METROPOLITAN GOVERNMENT OF NASHVILLE AND DAVIDSON COUNTY

STAFF RECOMMENDATION 1809 Sweetbriar Avenue June 20, 2012

Application: Infill and Accessory structure
District: Belmont-Hillsboro Neighborhood Conservation Zoning Overlay
Council District: 18
Map and Parcel Number: 11704006000
Applicant: Brent Craig, Rigid Development
Project Lead: Melissa Baldock, melissa.baldock@nashville.gov

Description of Project: The applicant is proposing to construct a new one-and-half-story house and a two-story accessory structure on a vacant lot.

FRONT ELEVATION
 SCALE: 1/4" = 1'-0"

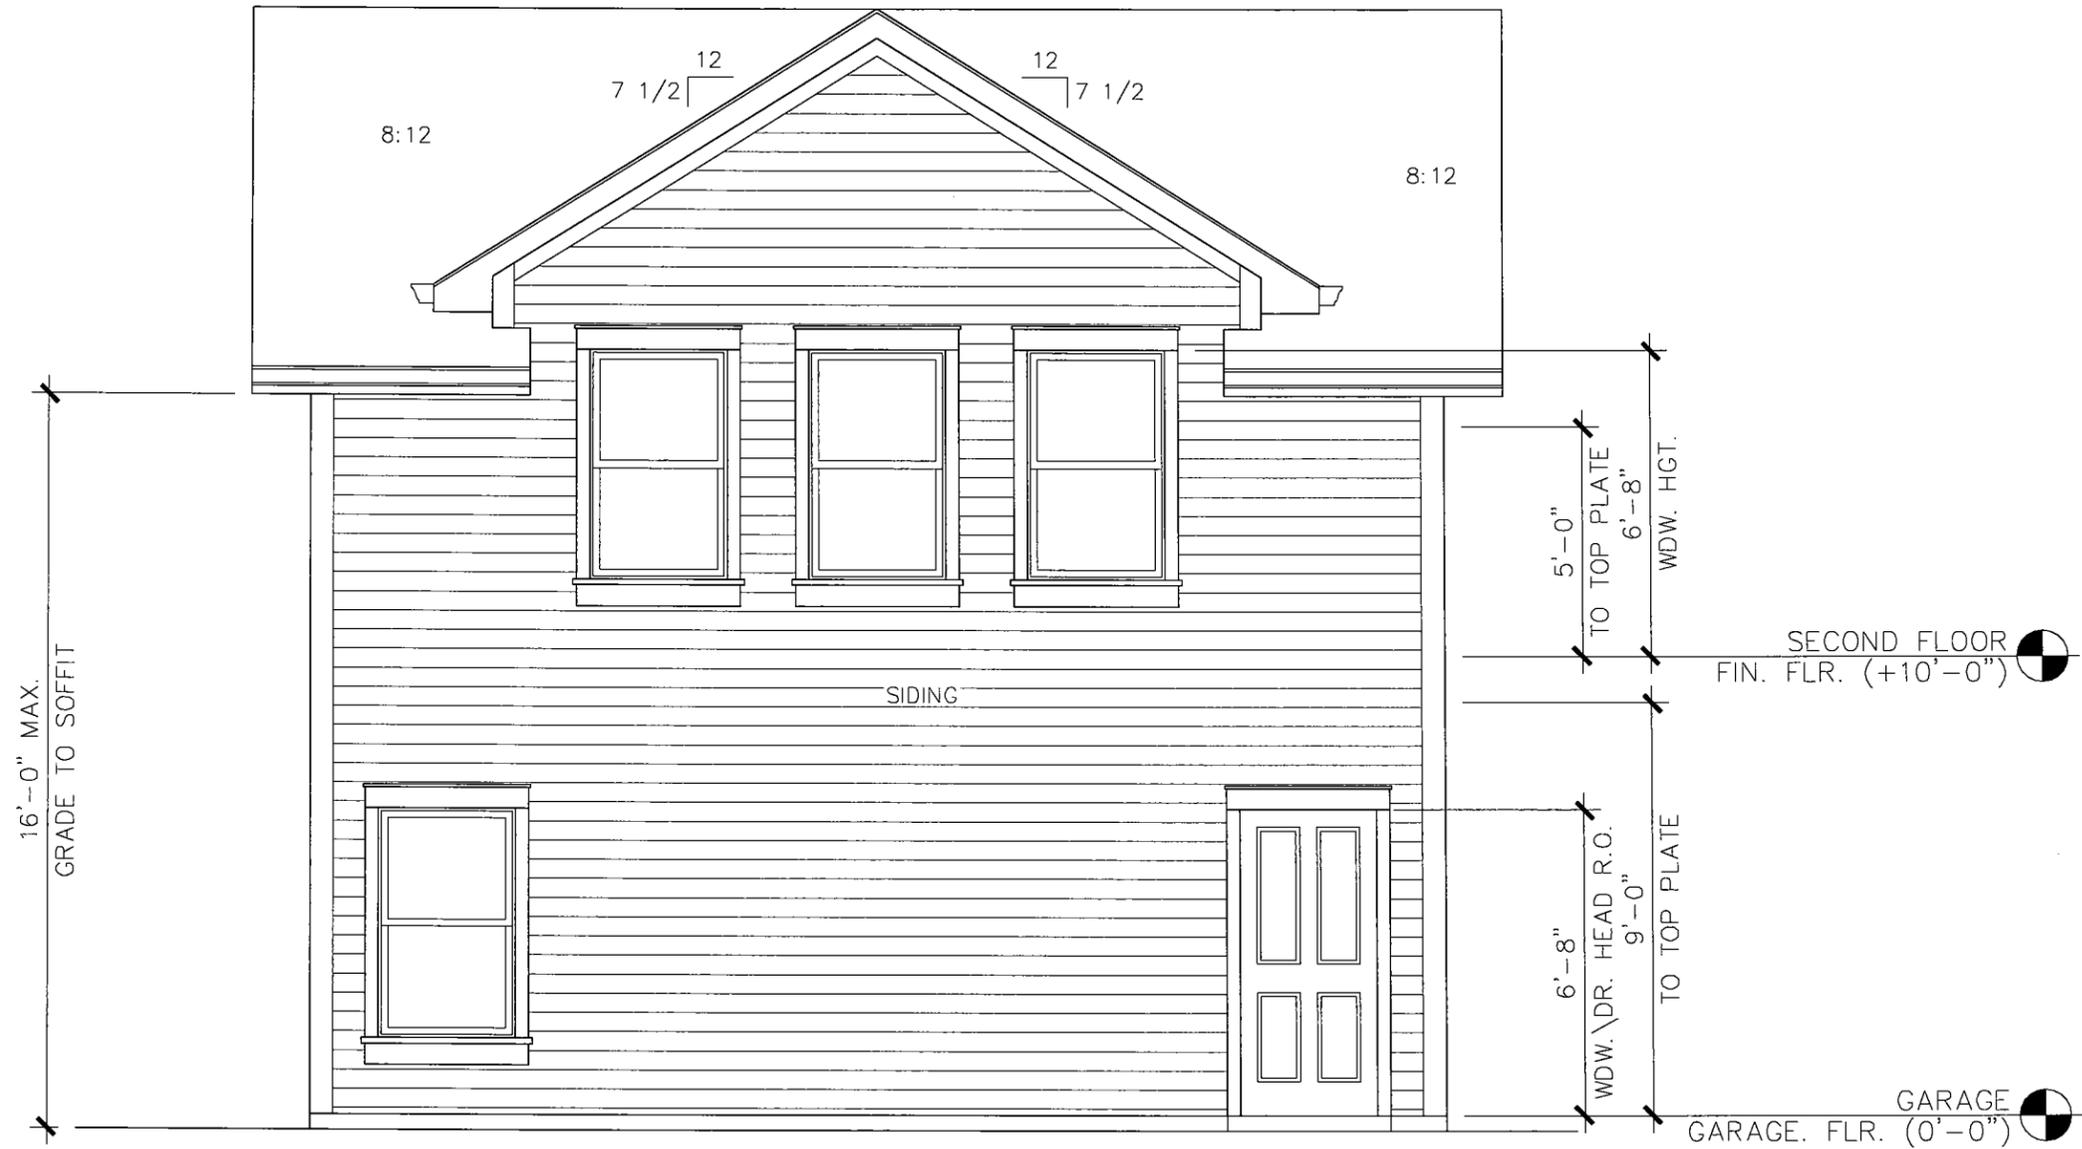
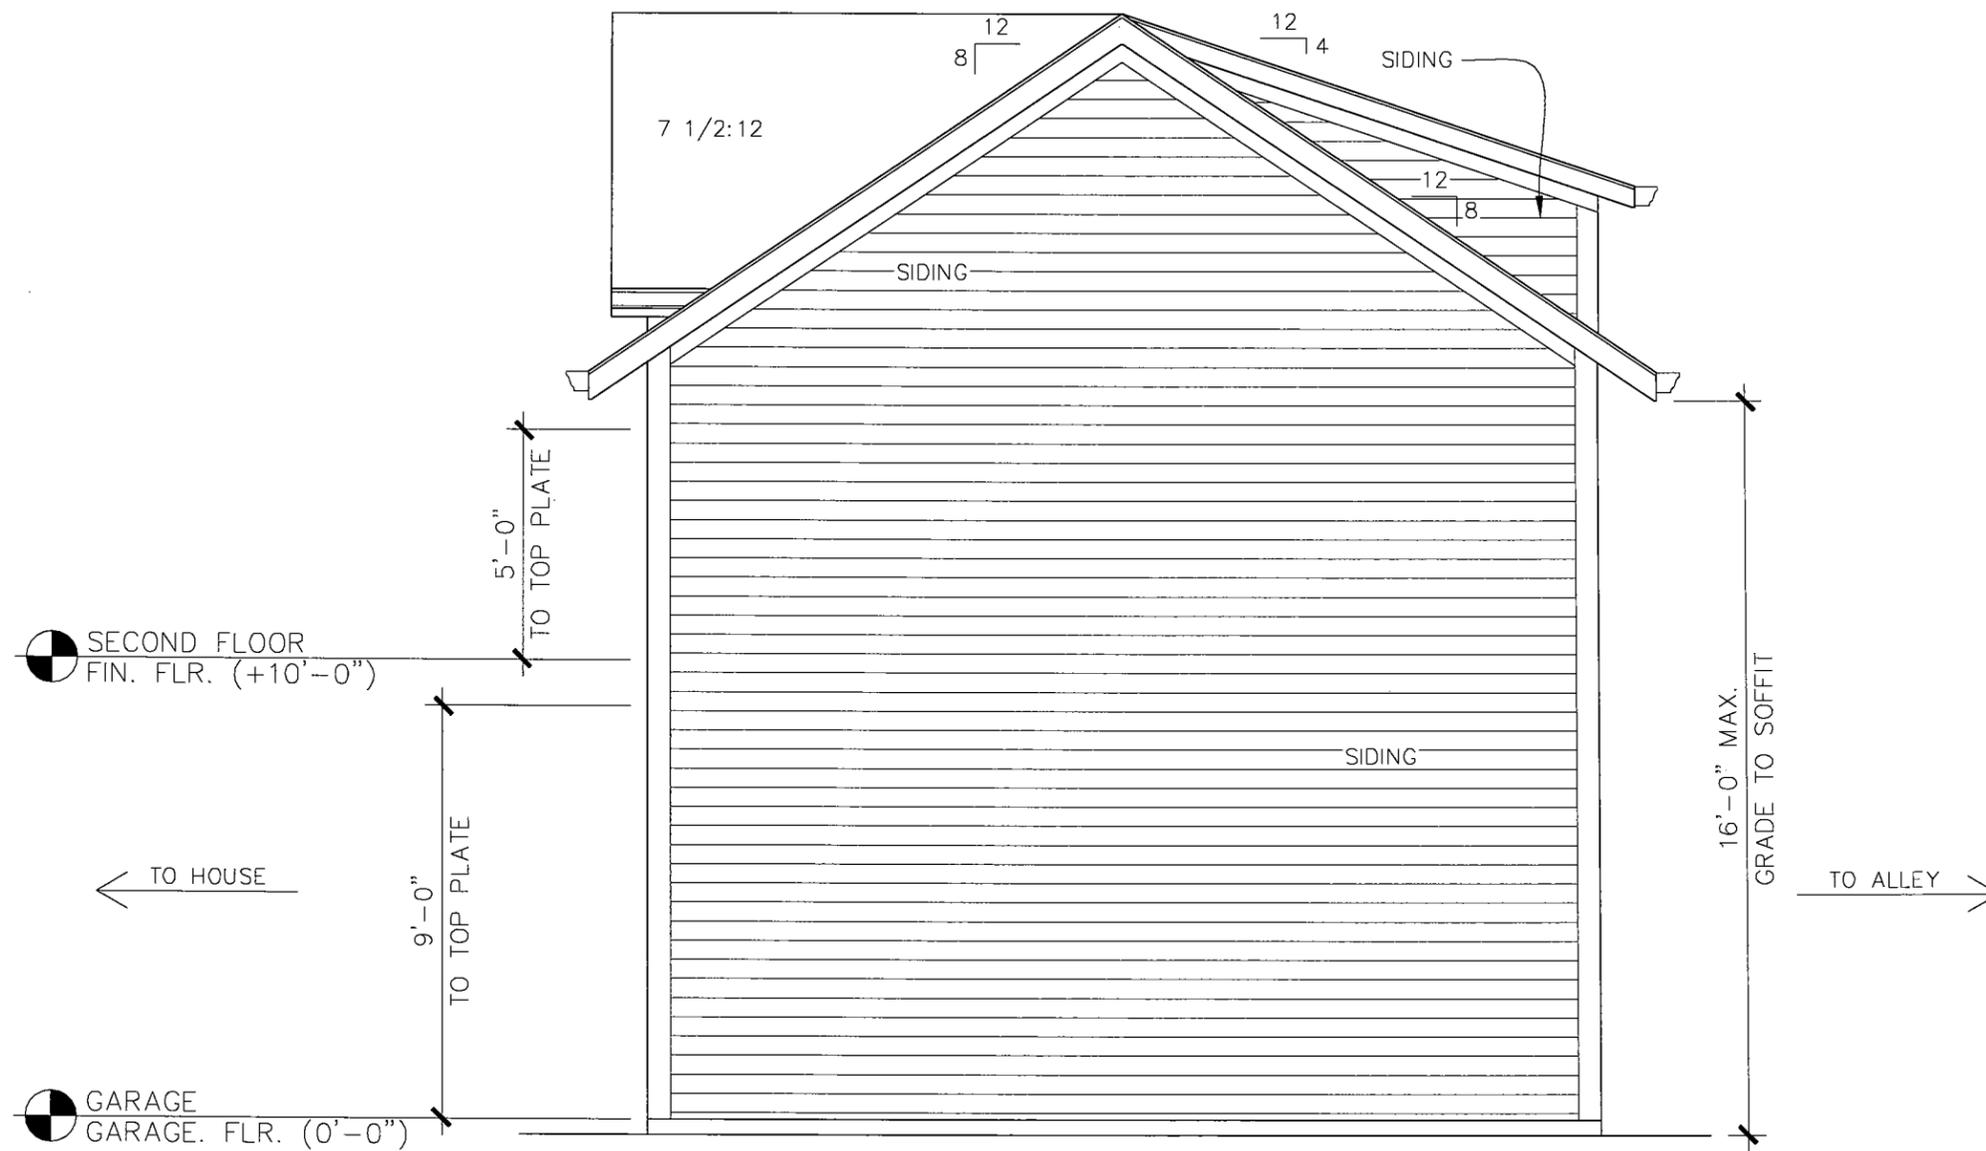
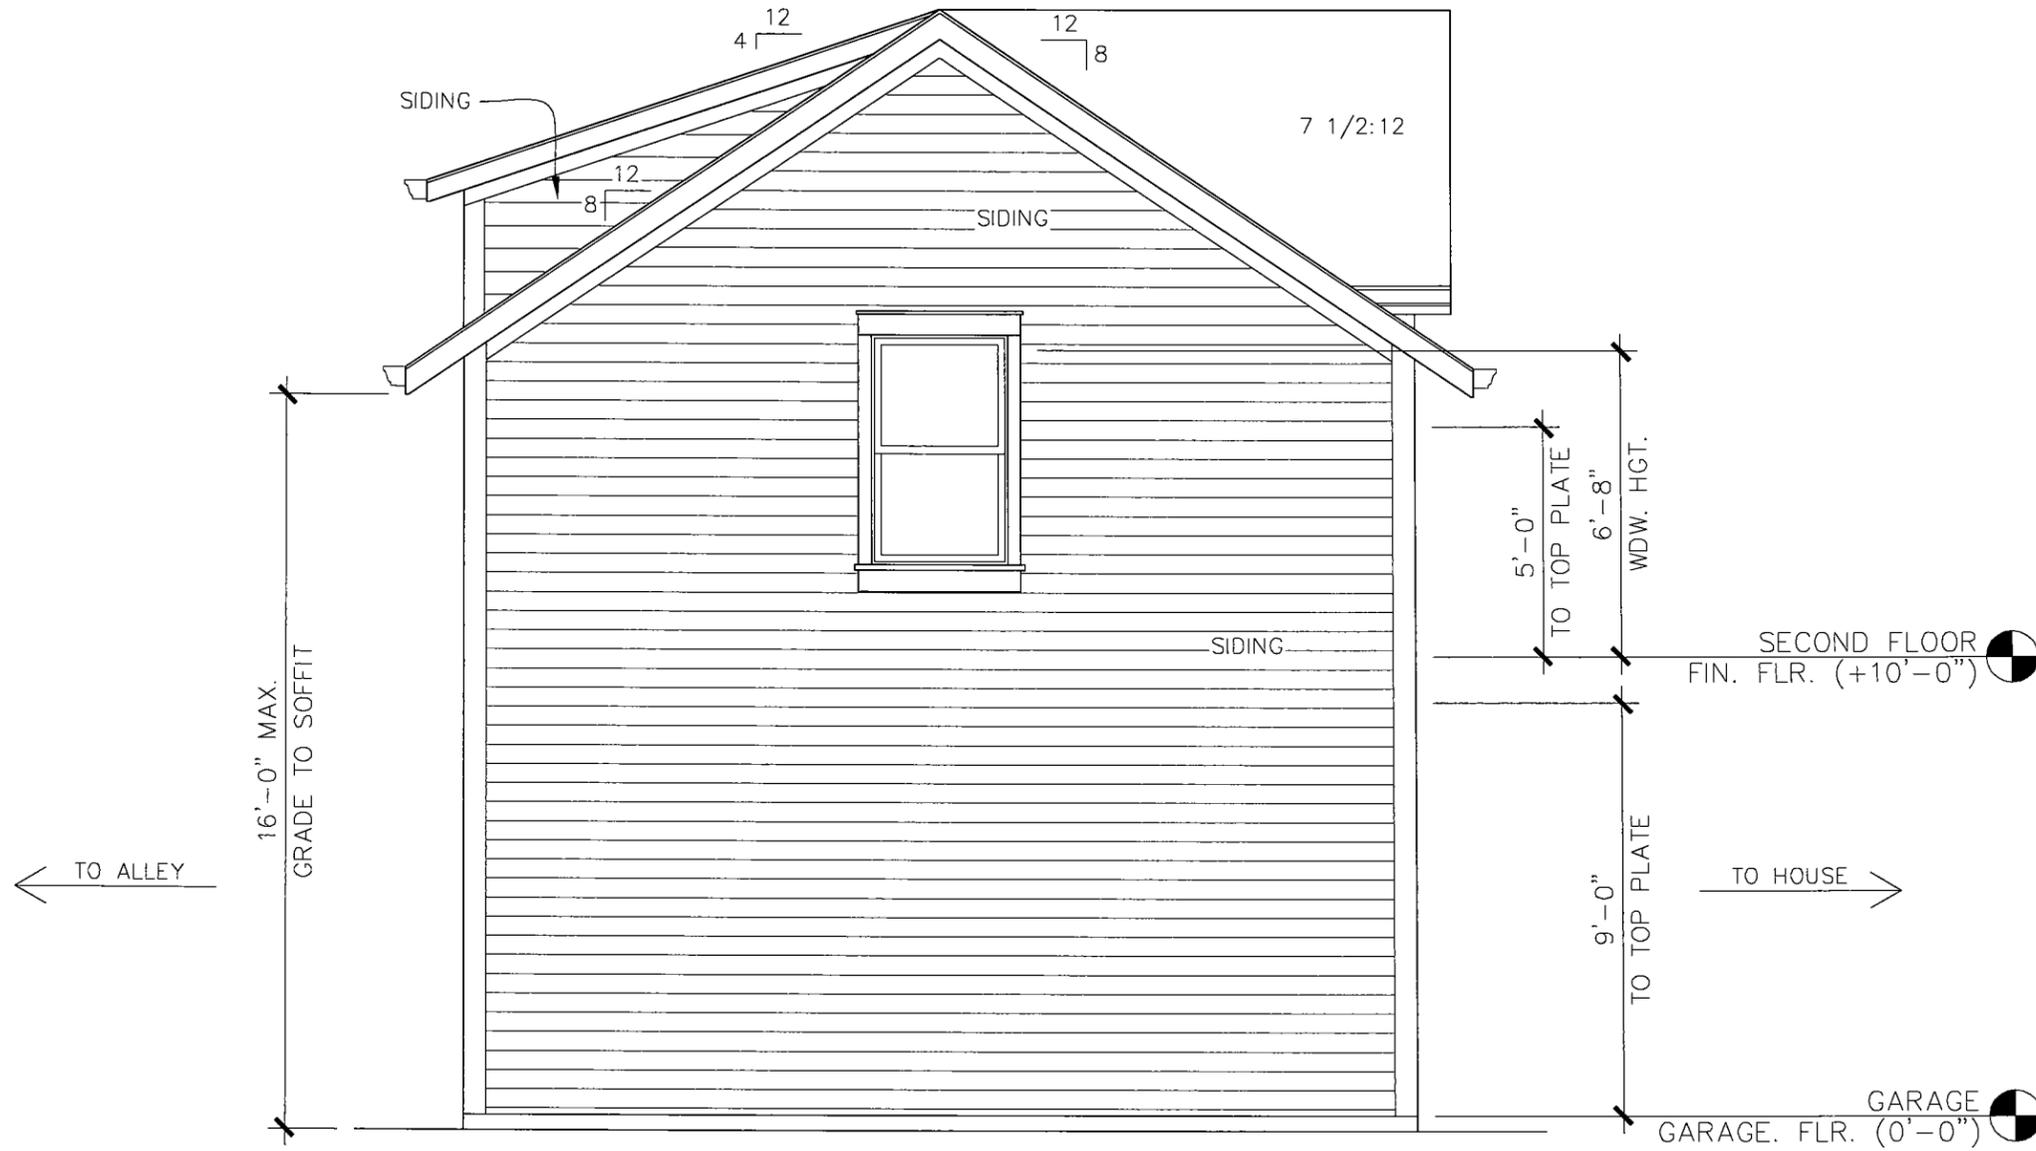
The accessory structure is proposed to have an eave height of sixteen feet (16') and a ridge height of twenty-four feet, six inches (24'6"). Staff finds that the height of the accessory structure is not subordinate to the proposed infill, which will have an eave height of twelve feet, nine inches (12'9") and a ridge height of twenty-six feet, nine inches (26'9"). Moreover, the accessory structure is not subordinate to the immediate historic context, where the primary structures range in height from eighteen feet to twenty-four feet (18'-24'). Staff asks that the ridge height be lowered to approximately twenty feet (20') from grade and that the eave height be lowered by a minimum of two feet (2') so as to be subordinate to the infill and to the neighborhood context. Staff notes that new drawings showing the grade of the site as it relates to accessory structure are necessary to ensure that the eave height and ridge height are truly below the ridge and

eave height of the primary structure. Lastly, staff asks that a trim board be added to the garage at the floor level to help minimize the perceived height of the structure.

9. The ridge height of the accessory structure be a maximum of twenty feet (20') and the eave height be lowered by a minimum of two feet (2').
10. A trim board be added to the accessory structure's floor level, and staff approve all of the structure's windows, doors, and roof color.
